**Reference: St. Columban Wind Project
Project Design Change Addendum Information Package**

ST. COLUMBAN ENERGY LP
ST. COLUMBAN WIND PROJECT

ST. COLUMBAN WIND PROJECT

Revision 5-101 Addendum 1

Figure 2-1 Wind Farm details map.

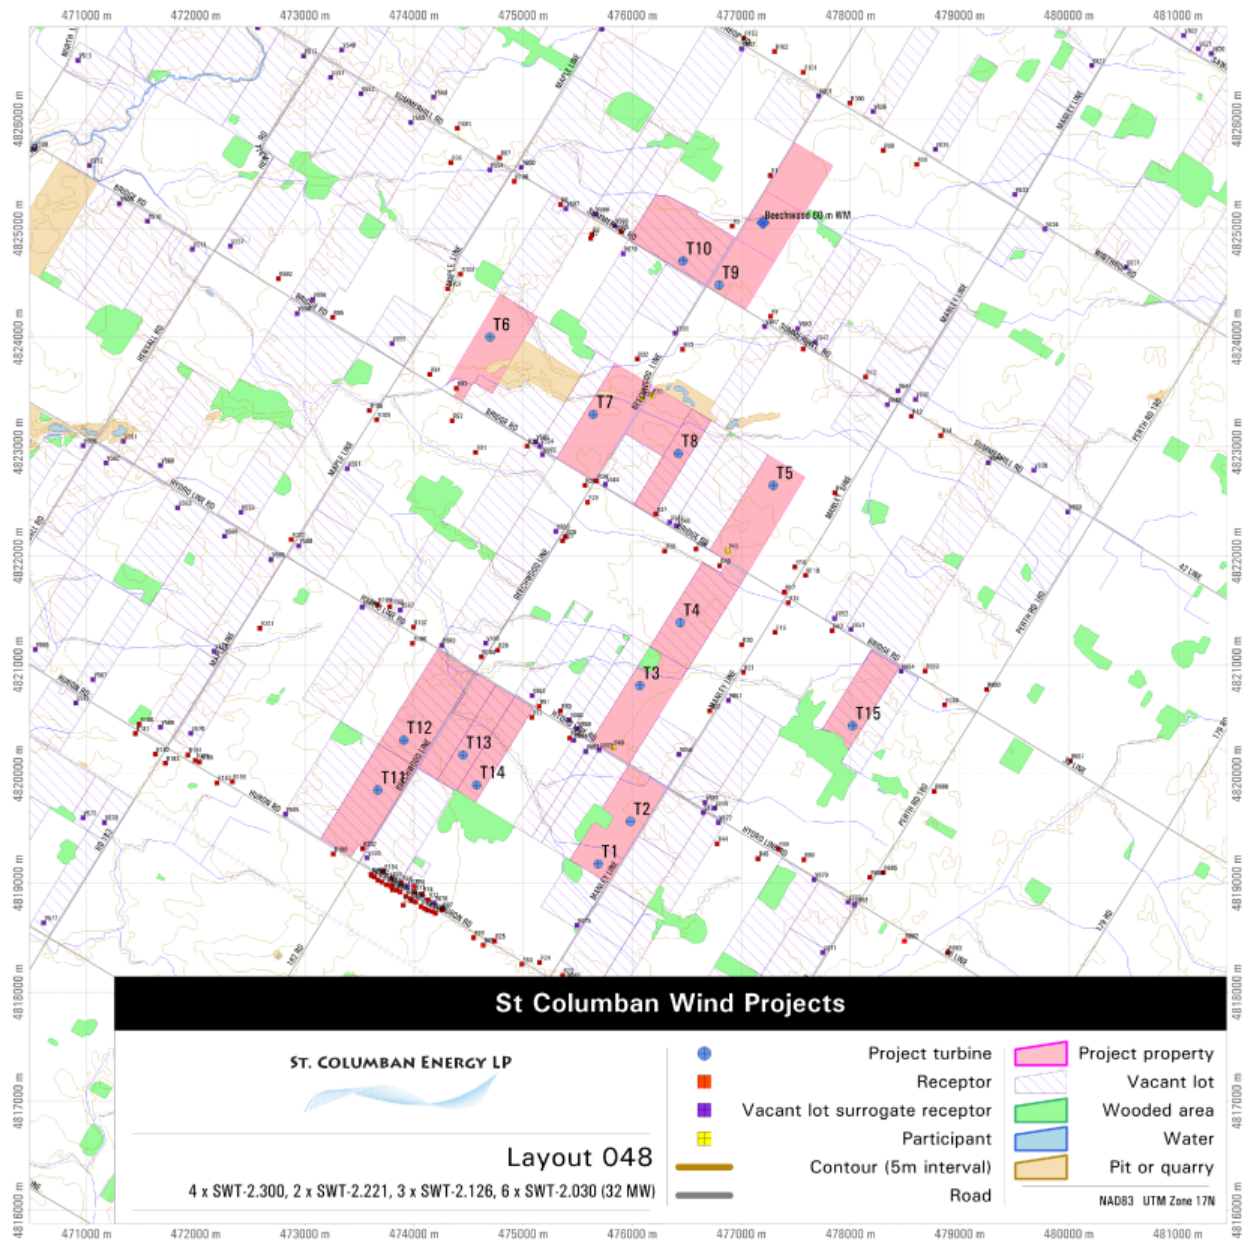
1. Relocation of turbine T10 within its host property. This turbine has been moved to 476,464E 4,824,699N (NAD83, UTM17N) from 476,414E 4,824,755N.
2. Relocation of vacant lot surrogate receptor (VLSR) V679 in response to a request from the landowner. This VLSR has been moved from 475,862E 4,824,661N (NAD83, UTM17N) to 475,917E 4,824,767N.

Figure 2-1 has been updated to show the new locations of T10 and V679.

Figure 8-1 40 dBA noise isopleth map for 6 ms⁻¹ (10 m) for 1.5 and 4.5 m receptor heights.

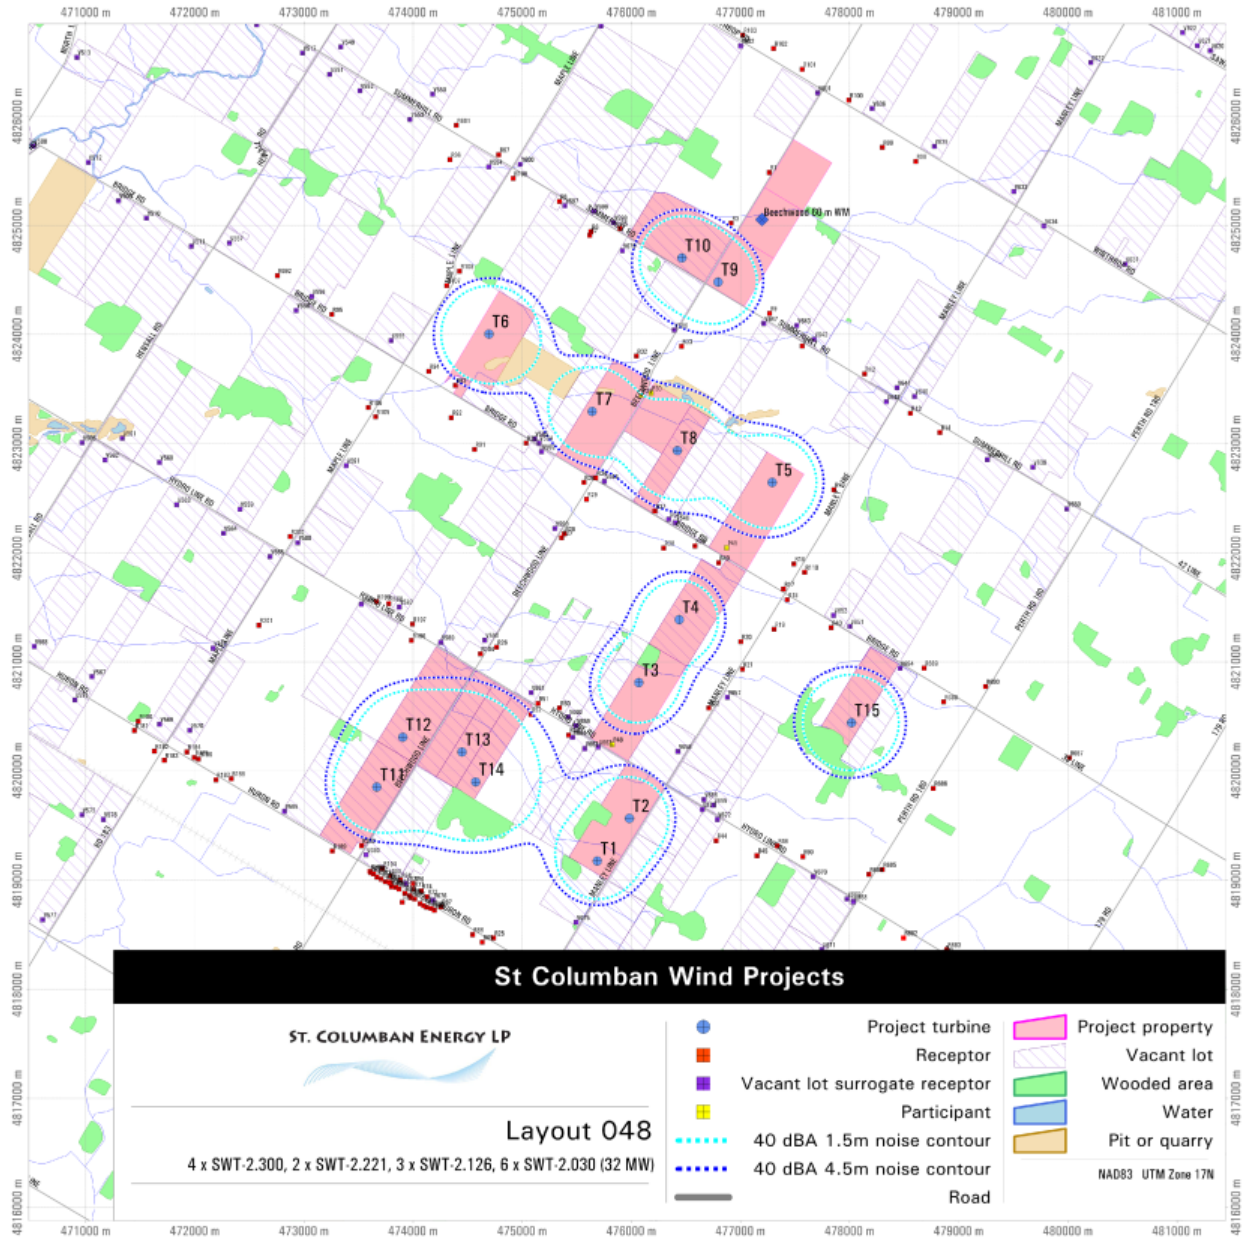
Figure 8-1 is an updated noise level isopleth map of the sound pressure levels (dBA) due to turbines and transformers (as existent) over the project area for a 10 m a.g.l. wind speed of 6 ms^{-1} . The noise levels are calculated for receptors with 1.5 m (1 storey) and 4.5 m (2 storeys) heights. Changes in this map are due only to the relocation of T10. (The updated location of V679 is also shown.)

Figure 2-1 Wind Farm details map.

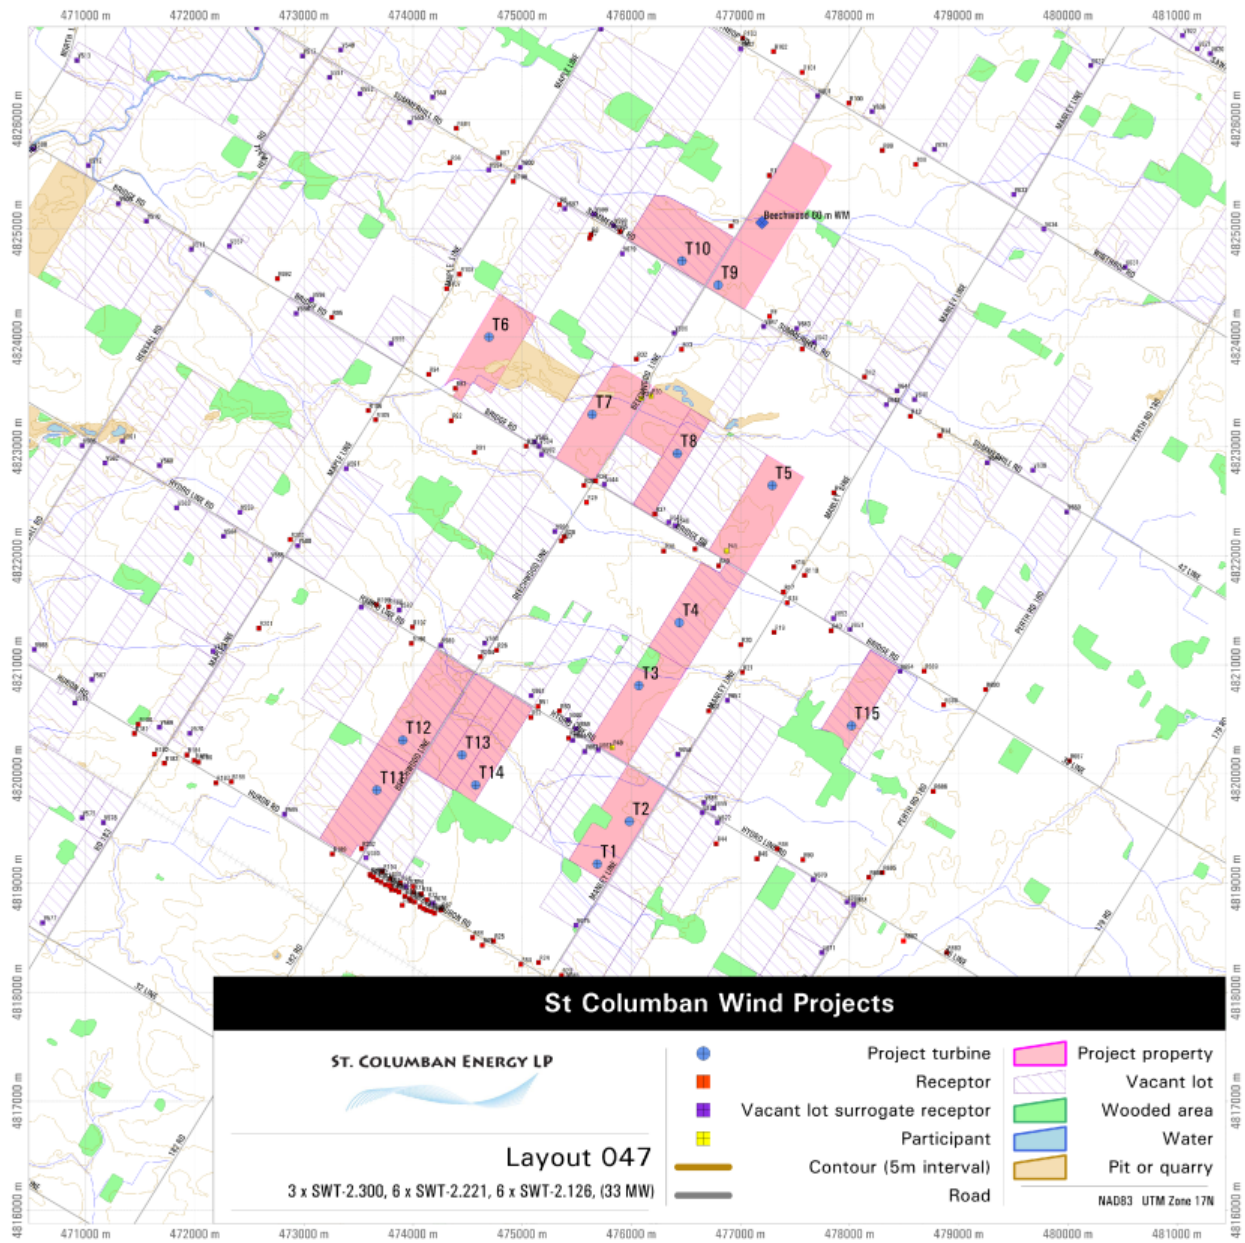
1. Relocation of turbine T10 within its host property. This turbine has been moved to 476,464E 4,824,699N (NAD83, UTM17N) from 476,414E 4,824,755N.
2. Relocation of vacant lot surrogate receptor (VLSR) V679 in response to a request from the landowner. This VLSR has been moved from 475,862E 4,824,661N (NAD83, UTM17N) to 475,917E 4,824,767N.

Figure 2-1 has been updated to show the new locations of T10 and V679.

Figure 8-1 40 dBA noise isopleth map for 6 ms^{-1} (10 m) for 1.5 and 4.5 m receptor heights.

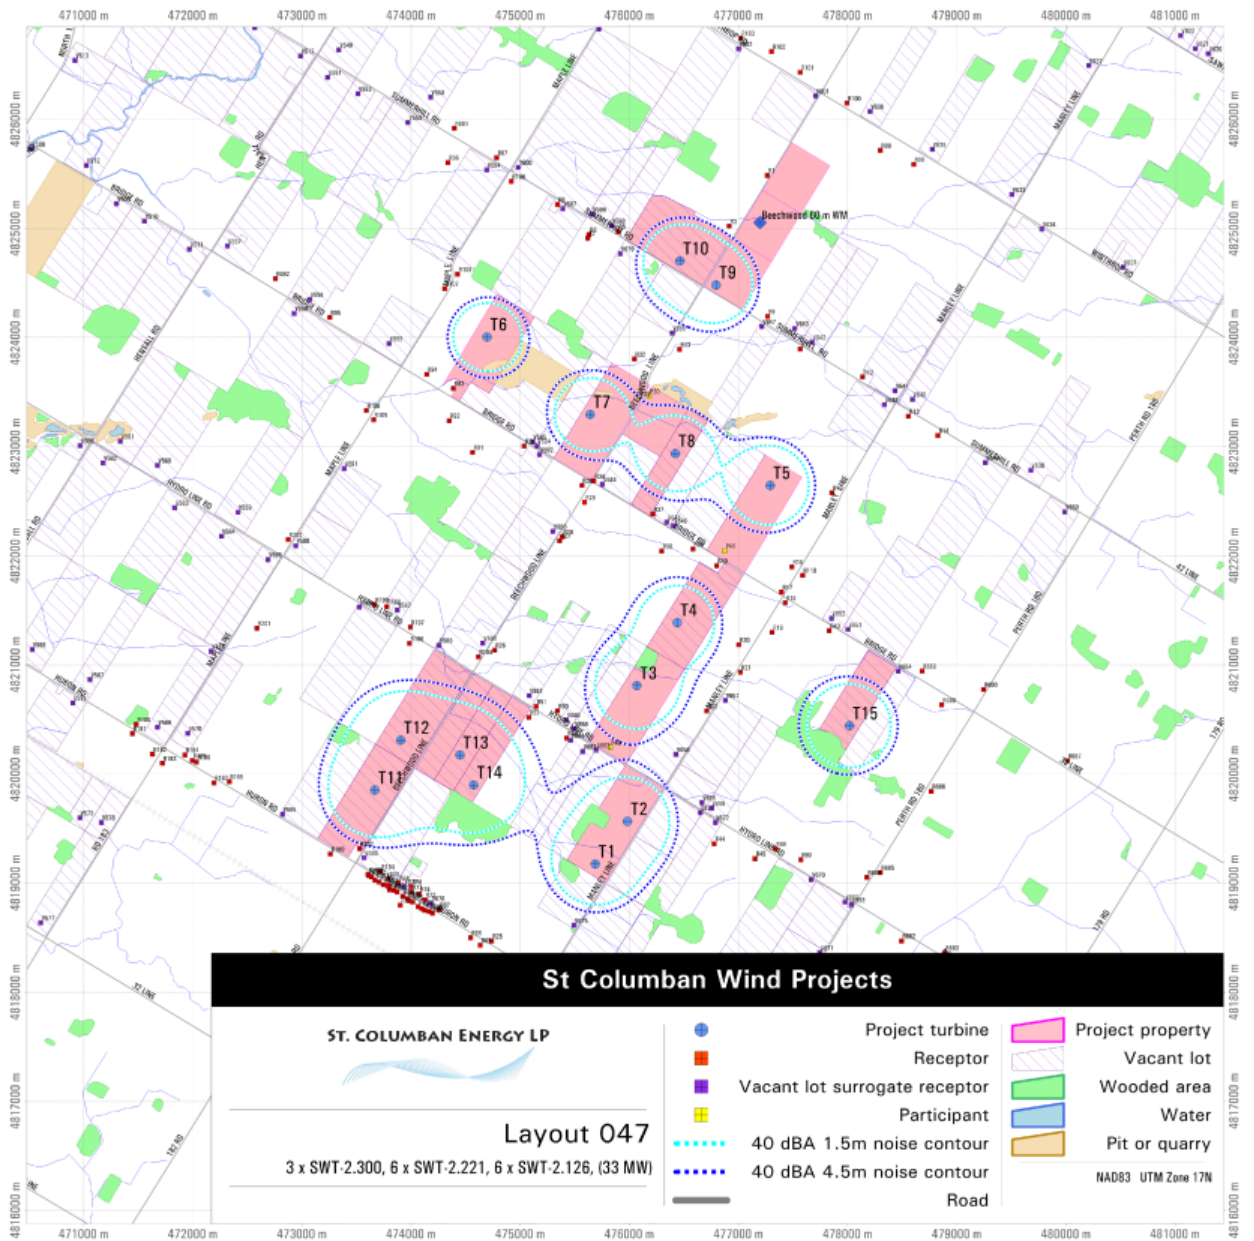
Figure 8-1 is an updated noise level isopleth map of the sound pressure levels (dBA) due to turbines and transformers (as existent) over the project area for a 10 m a.g.l. wind speed of 6 ms^{-1} . The noise levels are calculated for receptors with 1.5 m (1 storey) and 4.5 m (2 storeys) heights. Changes in this map are due only to the relocation of T10. (The updated location of V679 is also shown.)

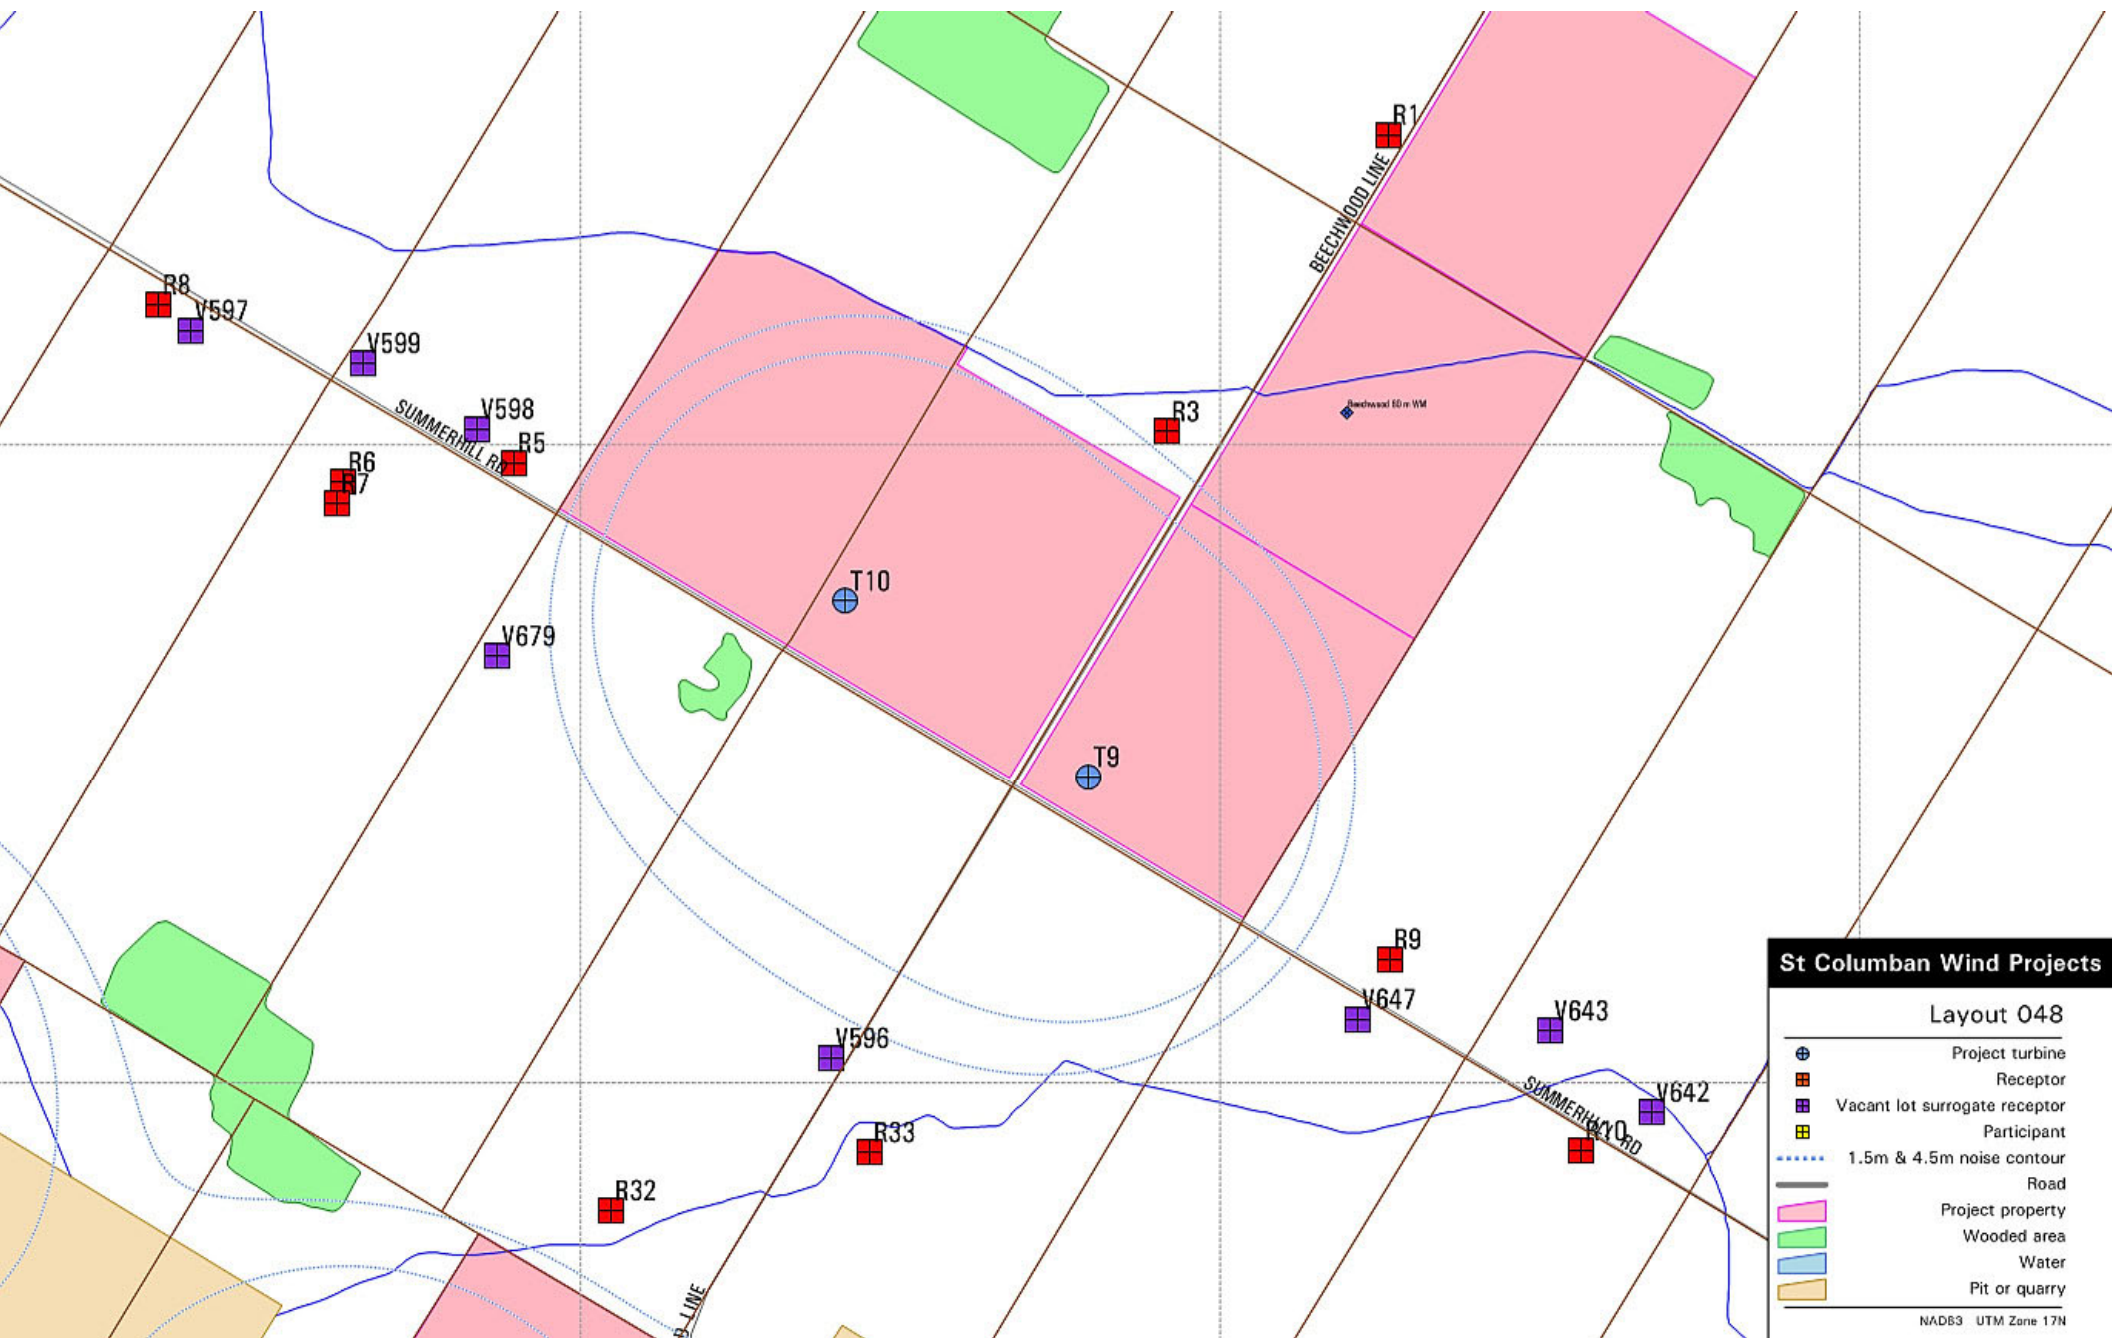
In order to address your question, we have assumed that [REDACTED] is in fact a vacant lot, with a new VLSR labeled as V679. This new VLSR has been placed to meet the setback requirements, including being further than 550m from the closest turbine (T10), and maintaining noise levels below 40bBA. Attached is a drawing showing the location of the homes and turbines in the immediate vicinity of your home (including the new VLSR – V679 on [REDACTED]). Please note that even though our noise modeling shows this VLSR – V679 is still some distance back from where the 40 dB noise levels are predicted (see outside dotted blue line for 4.5m or two storey home), the VLSR – V679 has been conservatively placed 560m away from the closest turbine T10.
